Lynn Gear Works

Redevelopment

Final Environmental Impact Report EEA #15441

March 10, 2017

Figure 1.2
Proposed Site Plan

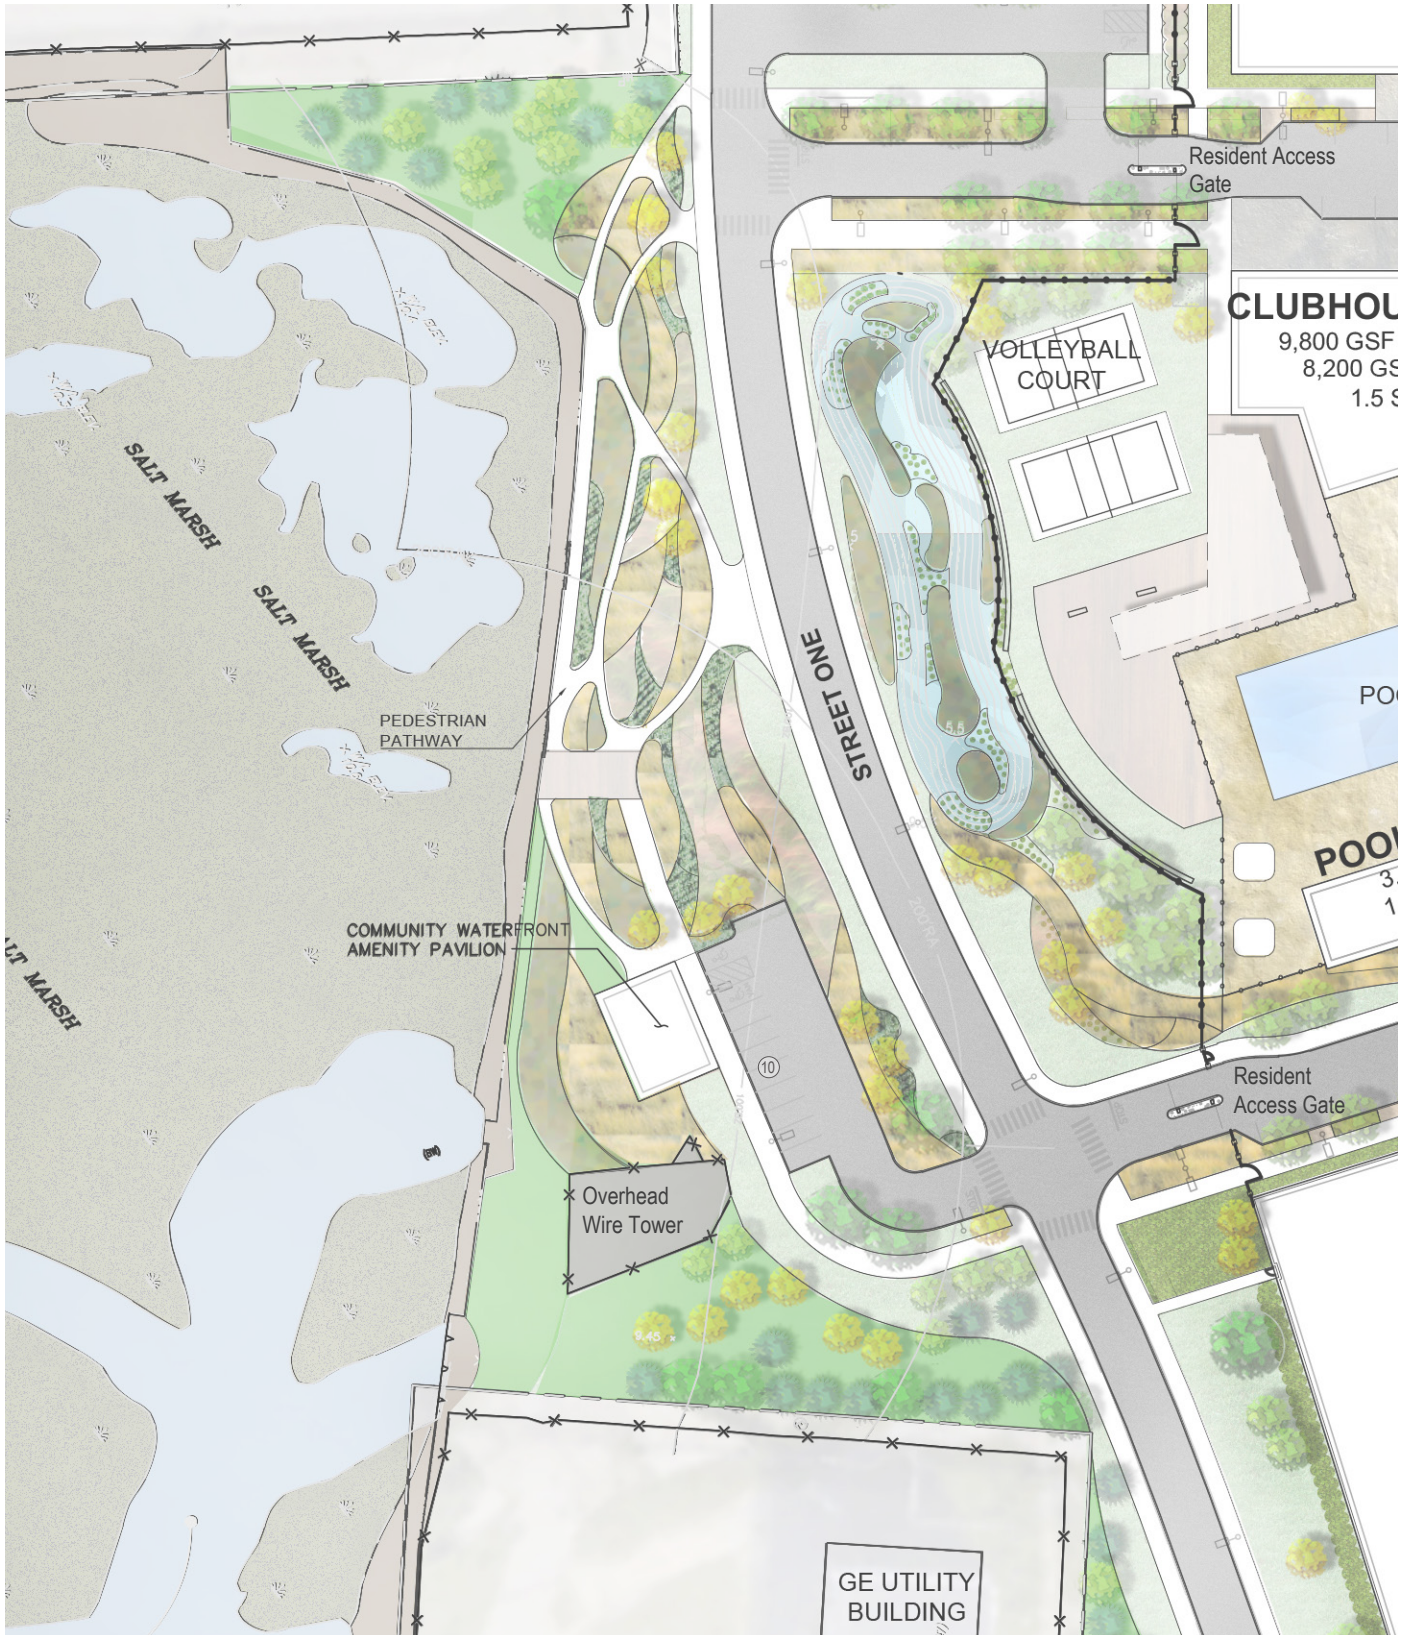
1.24 Figure 7.3 depicts a new internal roadway connection, parking, and Community Waterfront Amenity Building within the 100-foot buffer to the Coastal Bank and the Riverfront Area. The FEIR should address alternatives that would relocate these elements outside of the resource areas to minimize potential impacts to Coastal Bank and Riverfront Area.

1.24	Figure 7.3 depicts a new internal roadway connection, parking, and Community Waterfront Amenity Building within the 100-foot buffer to the Coastal Bank and the Riverfront Area. The FEIR should address alternatives that would relocate these elements outside of the resource areas to minimize potential impacts to Coastal Bank and Riverfront Area.	Chapter 4, Section 4.1.5, Riverfront Area, provides the requested information.

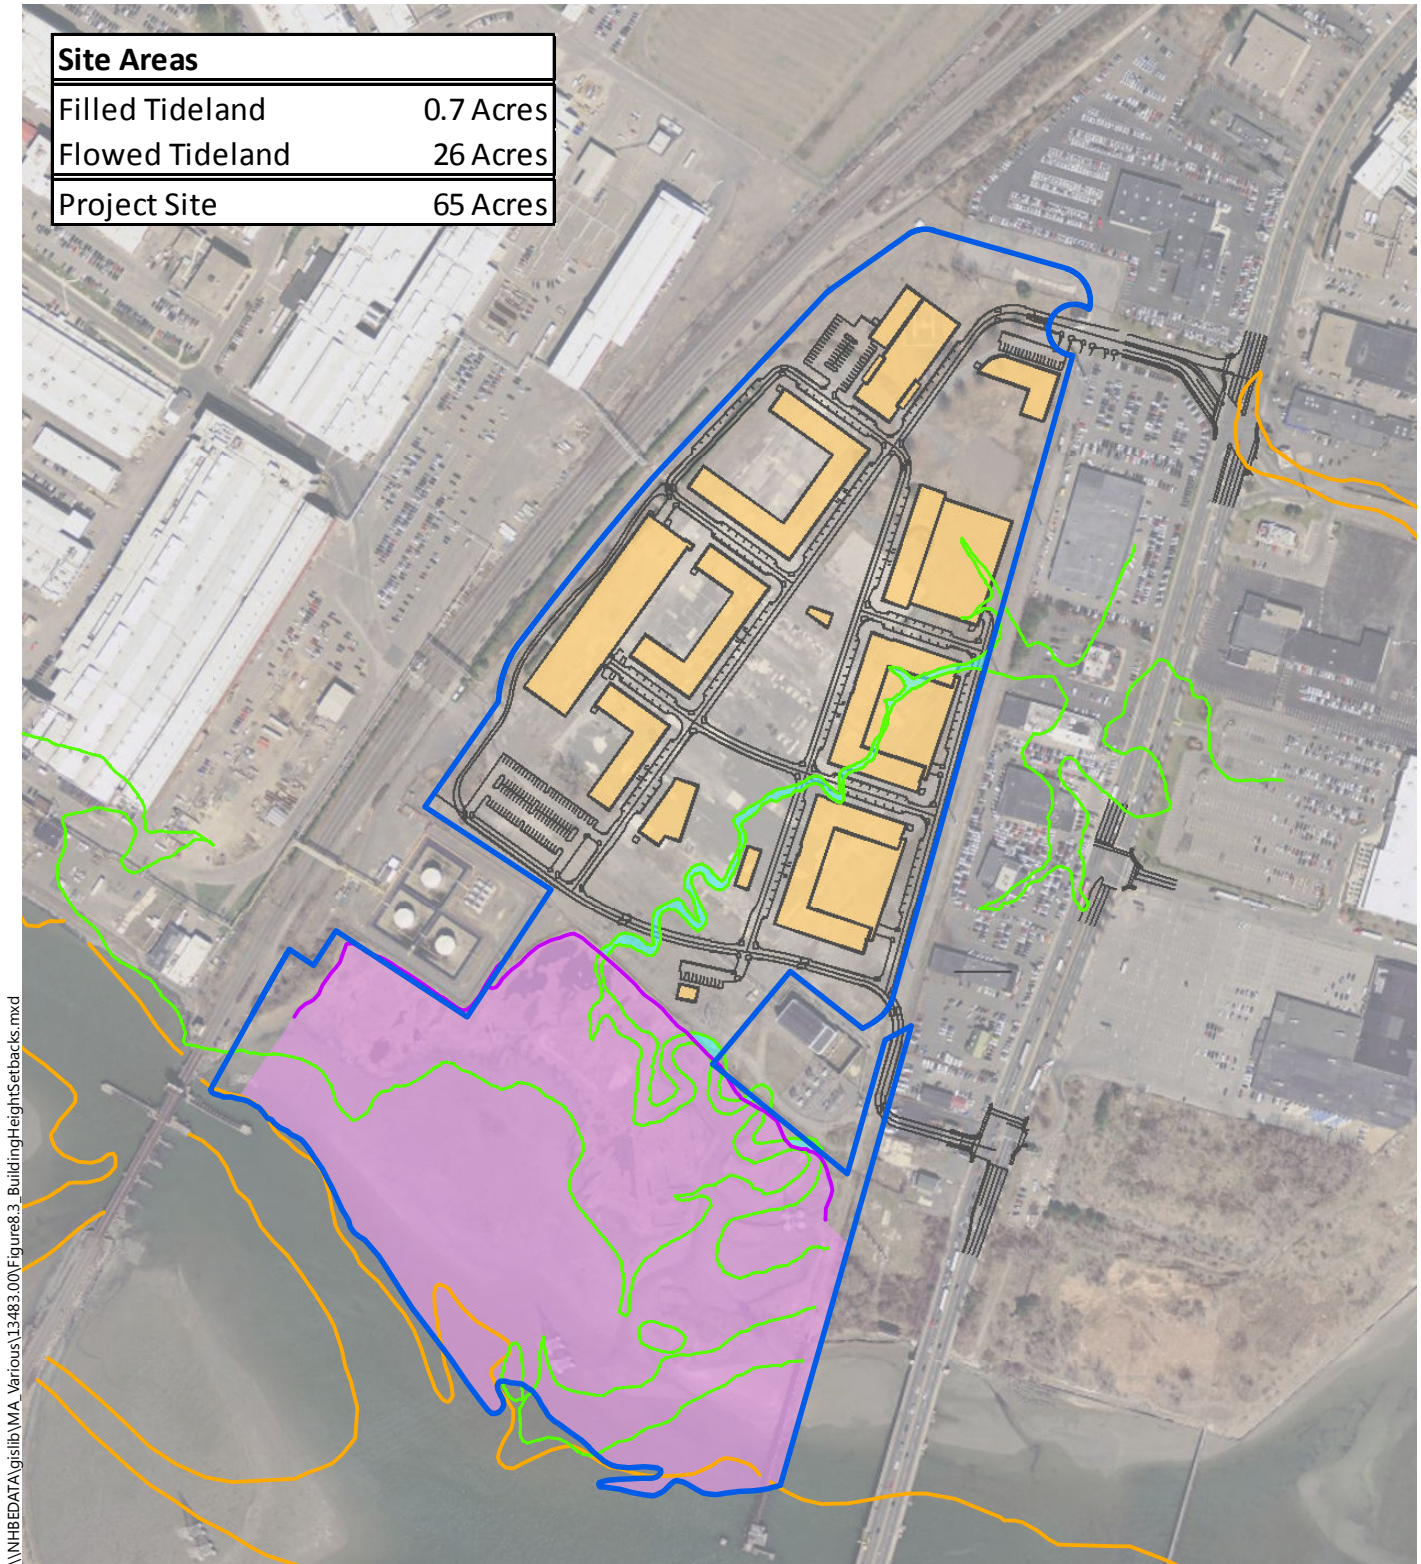
1.15	Plans submitted with the FEIR should clearly identify existing and proposed elevations, at a reasonable scale, associated with fill and grading.	Figures 4.3 and 4.4 in Chapter 4 provide the requested information.
